RAYTHEON COMPUTER
CUSTOMER SERVICE CHANGE ORDER

C.S.C.O. No. 32

Subject Delay Lines Adjustment

Purpose To standardize delay line adjustment procedure

FIGURE 1

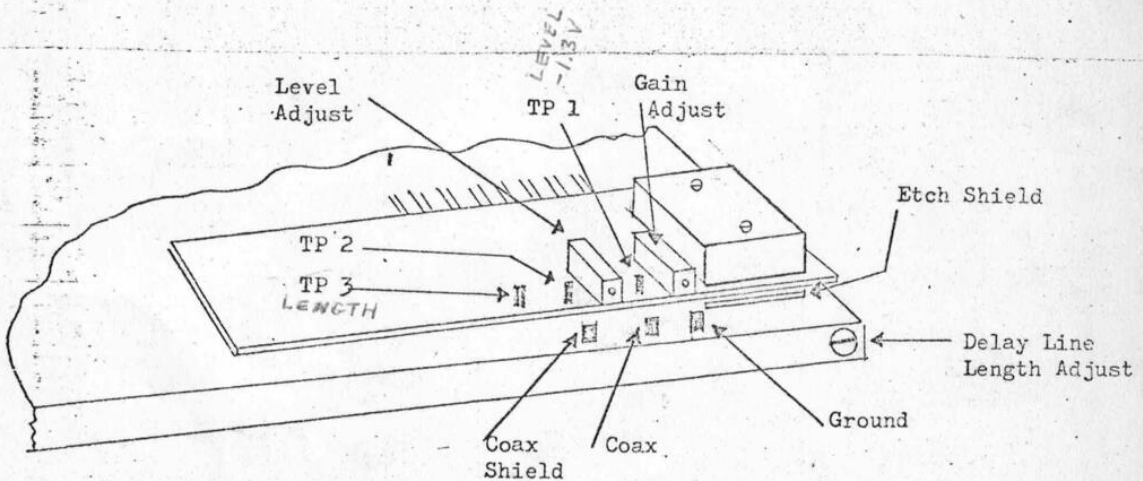
Perform all adjustments in the order listed, see figure 1 for identification of points referred to.

FIGURE 3

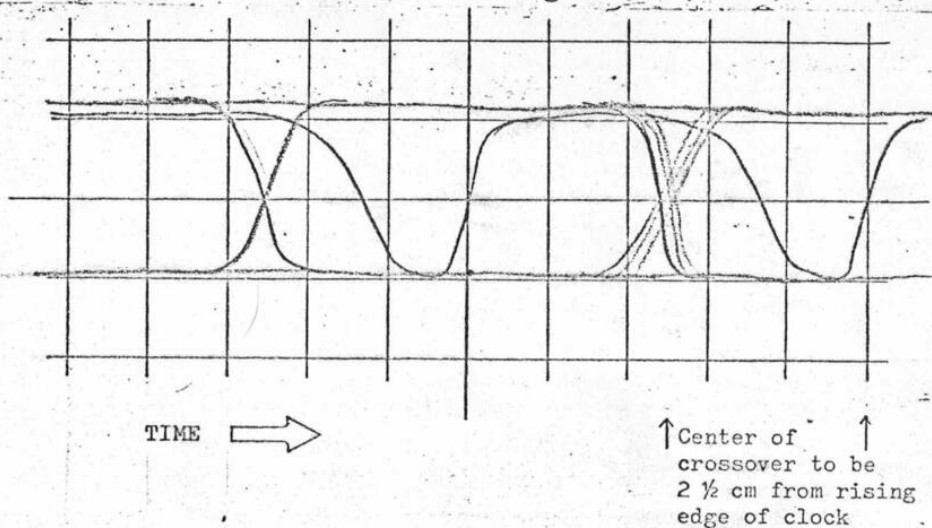
Note: In making the fine length adjustment certain precautions should be taken. If the line is a sealed line manufactured by Ferranti, Delttime or Anderson initially adjust the line to be .3 microseconds shorter than the correct delay. This is done by turning the length adjustment screw in the clockwise direction. The final length adjustment should be made with a counter-clockwise rotation of the adjusting screw.

Adjust length adjustment screw until wave shape is obtained as shown in figure 3.

FIGURE 4

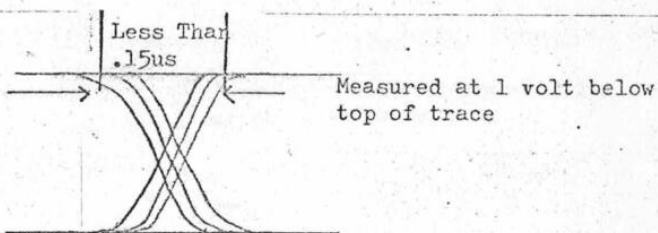
Switch plug in Mode to A ONLY. Examine wave shape for correct width as shown in figure 4.

If the width of the dispersion is greater than .15 us the line should be removed for repair.

FIGURE 5

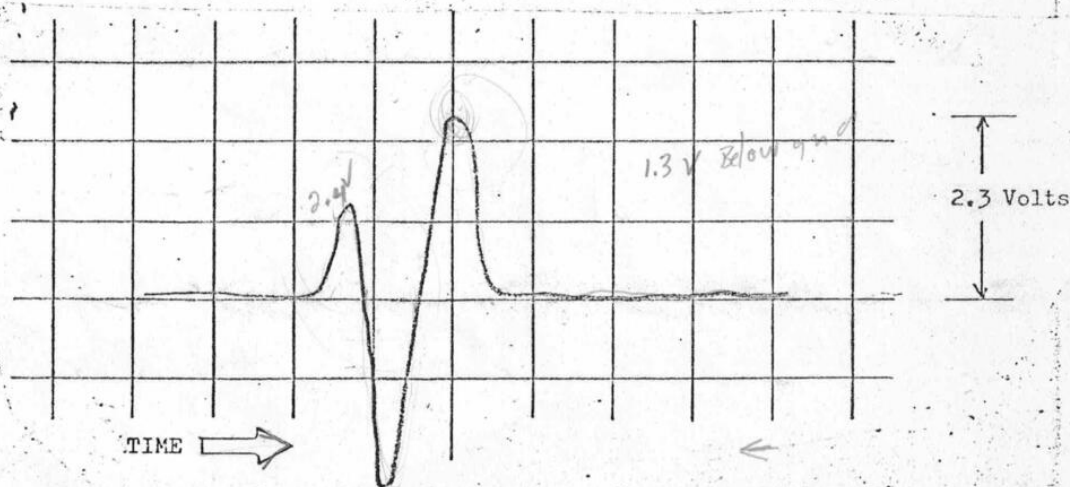
With a jumper lead connect Tp 3 of memory line to P24. Wave shape obtained should be as shown in figure 5.

Adjust the pulse second in time for +2.3 volts amplitude with the Gain Adjust Trimpot. If +2.3 volts cannot be obtained remove the line for repair.

FIGURE 6

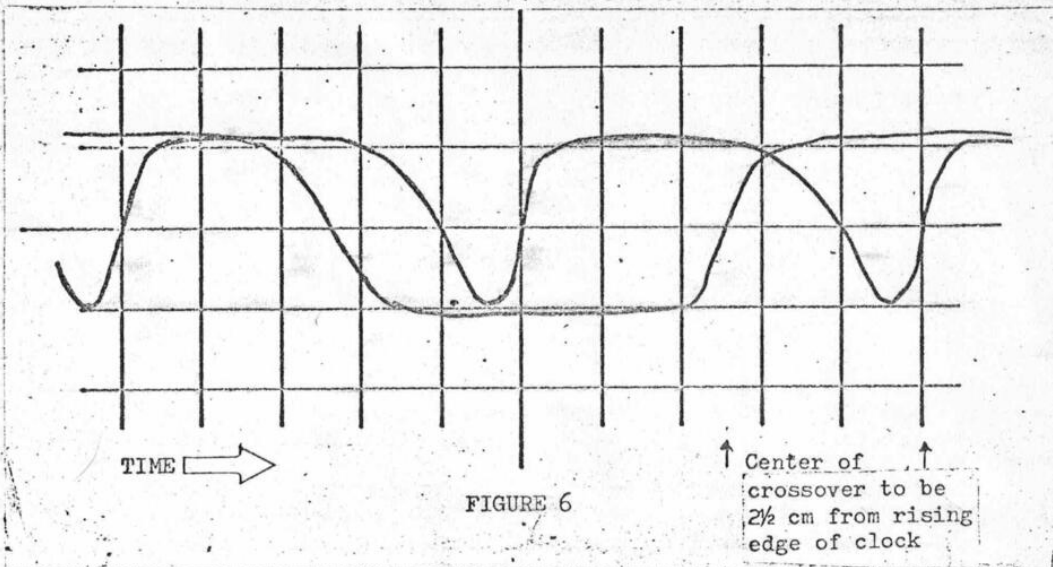
Note: In making the fine length adjustment certain precautions should be taken. If the line is a sealed line manufactured by Ferranti, Delttime or Anderson initially adjust the line to be .3 microseconds shorter than the correct delay. This is done by turning the length adjustment screw in a counter-clockwise direction. the final adjustment should be made with clockwise rotation of the adjusting screw

Adjust length adjustment until waveshape is obtained as shown in figure 6.
